Product / Process Change Notification

N° 2020-059-B !! UPDATE !!

Subject: Implementation of matrix leadframe for Package PG-TO252-3 in Tongfu Microelectronics Co., Ltd. (TFME)

Package Outer Dimensions

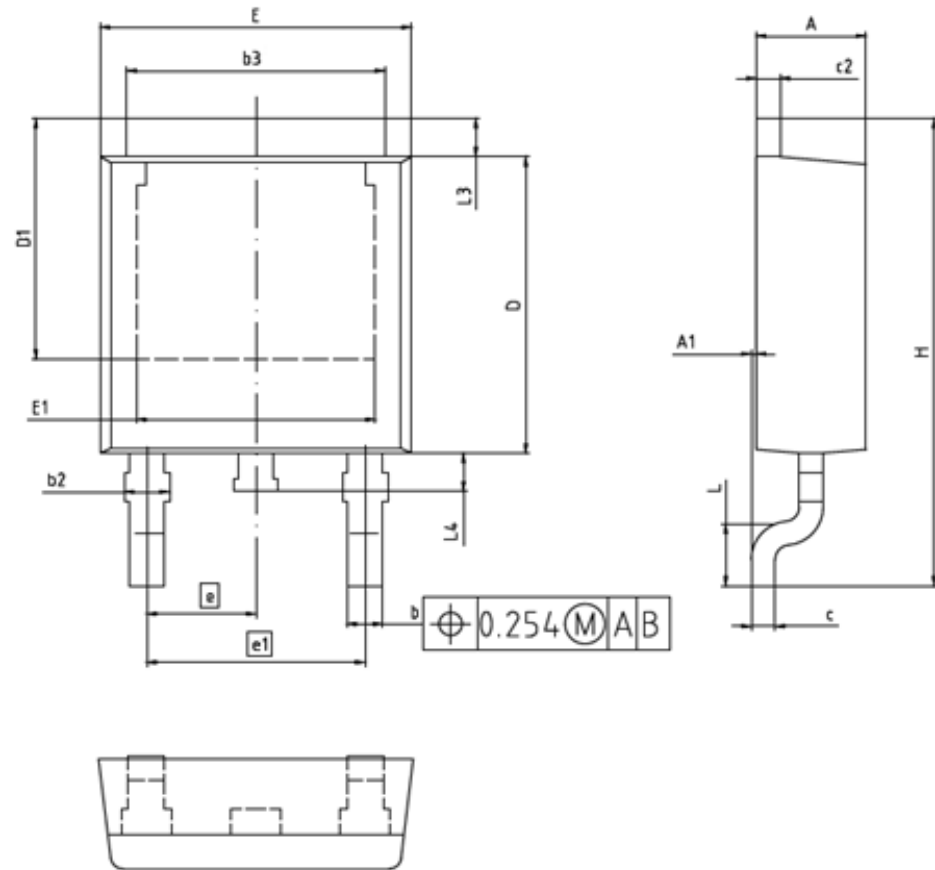
- > All package outer dimension are within the existing Infineon datasheet drawing with the exception of E1.(E1 updated from 5.21mm to 5.50 mm)
- > There is no impact in footprint, product quality, performance and reliability as verified by qualification.
